**IECC COMMERCIAL COMMITTEE ACTION REPORT ON THE
RESULTS ON THE 2021
PUBLIC INPUT CHANGES TO THE
INTERNATIONAL ENERGY CONSERVATION CODES-UPDATED 7/19/22**

Update July 19, 2022

CEPI-257-21

APPENDIX X THE 2030 GLIDE PATH

The Glide Path

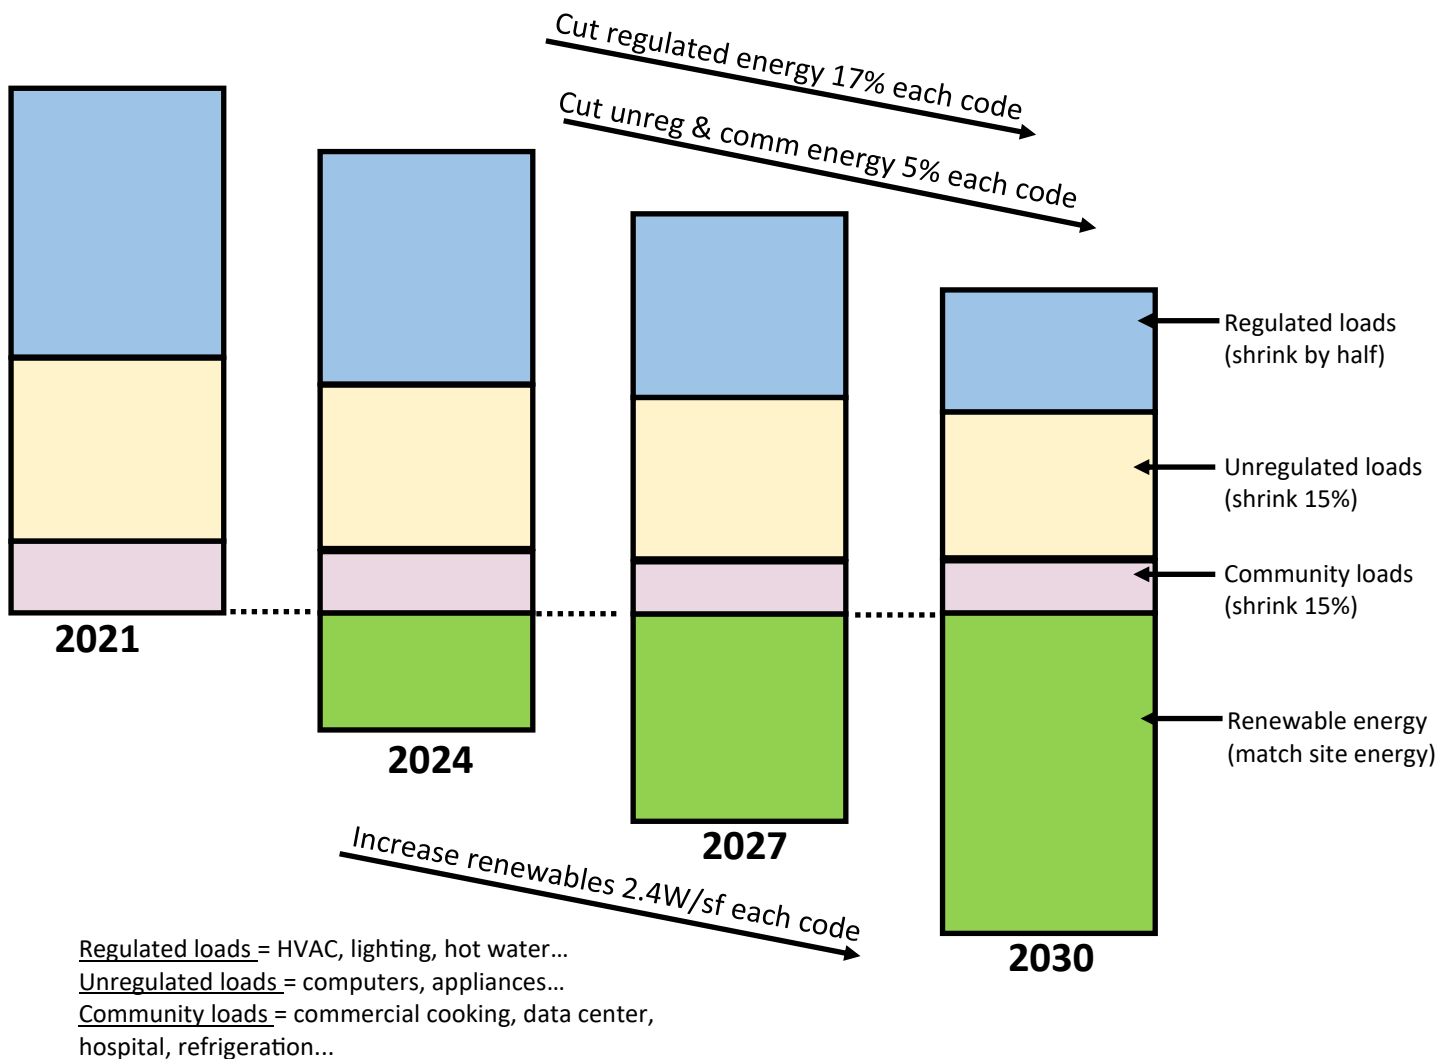
Reason: This appendix is intended to be adopted by jurisdictions that will require new construction to operate at net zero energy by the year 2030. It reduces the net annual energy use of buildings by approximately one-third in comparison with buildings constructed in compliance with the 2021 IECC, assuming that the 2027 and 2030 editions will also reduce energy use by one-third each.

It is estimated that *regulated* energy uses in buildings can be cut by 50% from current levels by 2030, but that unregulated loads and large community process loads will only diminish about 15% in the same time period. If regulated loads comprise 60% of building energy use, and unregulated loads (not counting large process loads) comprise the remaining 40%, halving the regulated loads would result in a 30% reduction in energy use, or 10% for each of the three Glide Path steps. Reducing unregulated and process loads by 15% over this decade would result in an additional 9% overall building energy use reduction by 2030, or 3% reduction per code cycle. Some of this 13% reduction (10% regulated and 3% unregulated/process) will occur in the base code development, and the remainder is required by this appendix.

For the 2030 ZNE target, renewable or site-recovered energy will be required to compensate for the remaining half of regulated energy use, plus the typical unregulated building energy use, and an additional amount to cover a proportionate share of community process energy.

Rather than burdening those buildings that contain large process loads (restaurant, grocery, hospital, data center, laboratory, etc.) with a requirement to provide renewable energy to cover their entire operating energy use, this Appendix requires an additional amount of renewable energy for *all* new building square footage in recognition of the fact that those large process loads serve the entire community with essential services. It is estimated that such community process loads equal approximately 20% of all other building energy loads.

If 39% of a building's net energy use reduction can be covered with efficiency and technology improvements, the remaining 61% of the *net* energy use reduction will be accomplished with acquisition of renewable energy resources, also in three roughly equal steps. Assuming typical PV production to be 1.5 kWh/year/watt, this would result in a requirement for 7 W/sf of conditioned floor area for 2030, or roughly 2.4 W/sf for 2024. For semi-heated or unconditioned space, the requirement will be 1/3 of this amount, or 0.8 W/sf for 2024.
